SUBJECT: Entergy Nuclear Operations Inc.
Indian Point Nuclear Generating Unit Nos. 2 & 3
Docket Nos. 50-247 and 50-286
Amendment 3 to License Renewal Application (LRA)

Regional Inspection LRA Amendment

**NRC Regional Inspection
 License Renewal Application
 Amendment**

Figure 2.5-2
IP2 Offsite Power Scoping Diagram

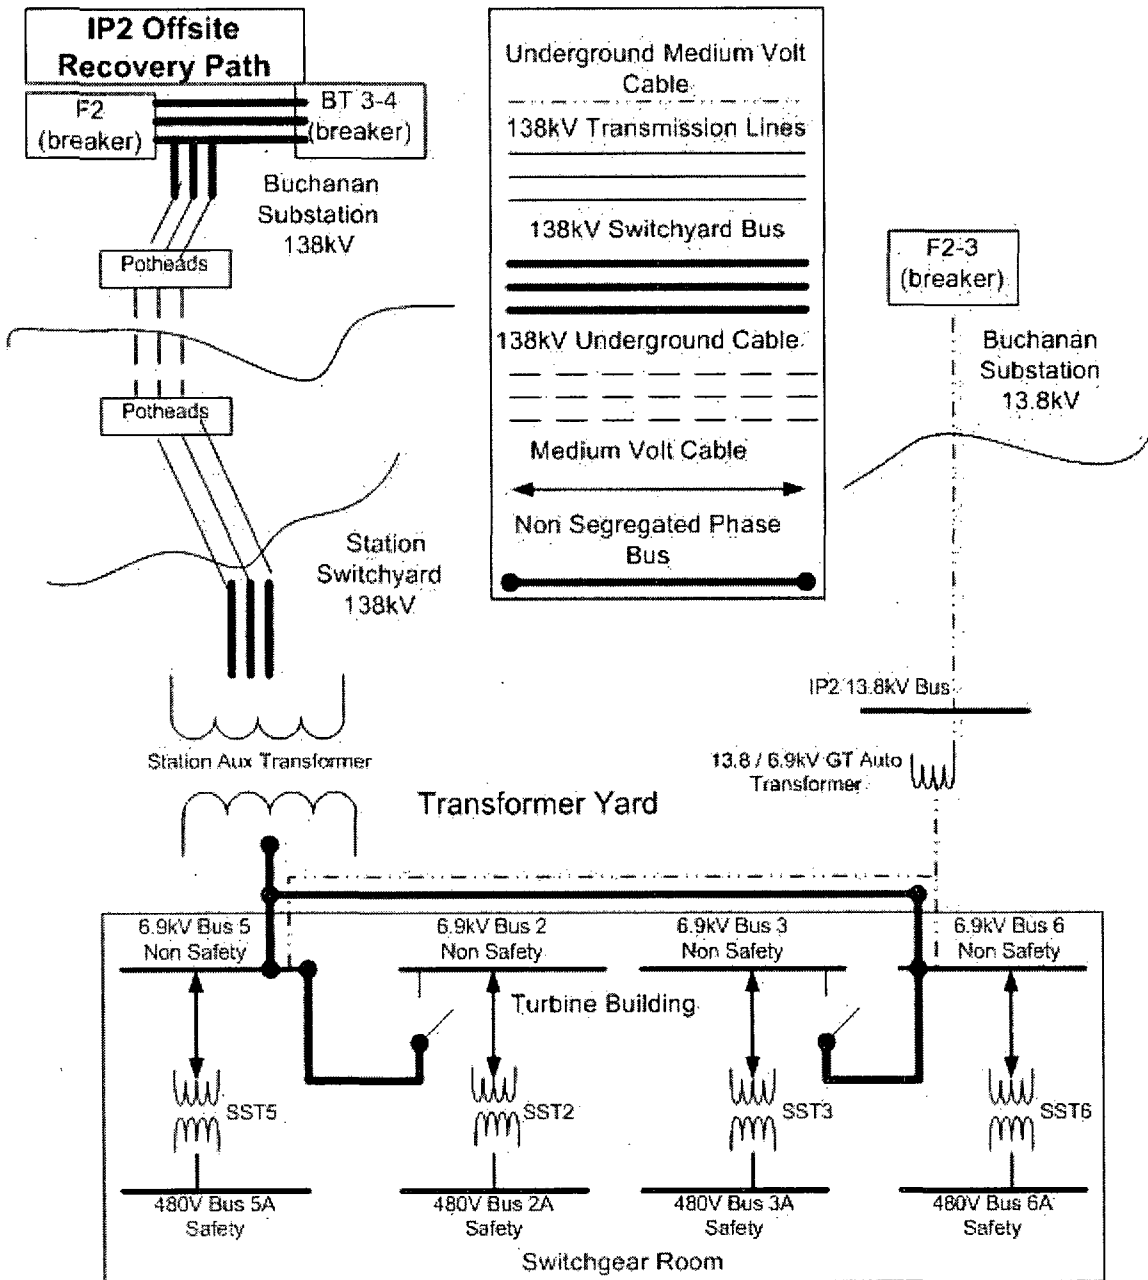
Based on discussion with the NRC Staff on 12/4/07 and industry discussion with the NRC Staff on 12/12/2007 and 1/30/2008, the response to this RAI provided in Entergy Letter NL-07-138, Dated 11/16/2007 is being revised. The only section that requires revision is LRA Figure 2.5-2 and associated discussion.

As shown in the revised LRA Figure 2.5-2, the 6.9 kV buses receive offsite power from either the 138 kV / 6.9 kV station auxiliary transformer or the 13.8 kV / 6.9 kV GT autotransformer. The station auxiliary transformer is connected to the 138 kV Buchanan substation, the primary offsite power source, via switchyard bus, overhead transmission conductors, and underground transmission conductors through ~~motor-operated disconnect F3A~~ switchyard breakers F2 and BT 3-4, which ~~is~~ are located at the Buchanan substation. The GT autotransformer is connected to the 13.8 kV Buchanan substation, the secondary offsite power source, via underground medium voltage cable through breaker F2-3, which is located at the Buchanan substation.
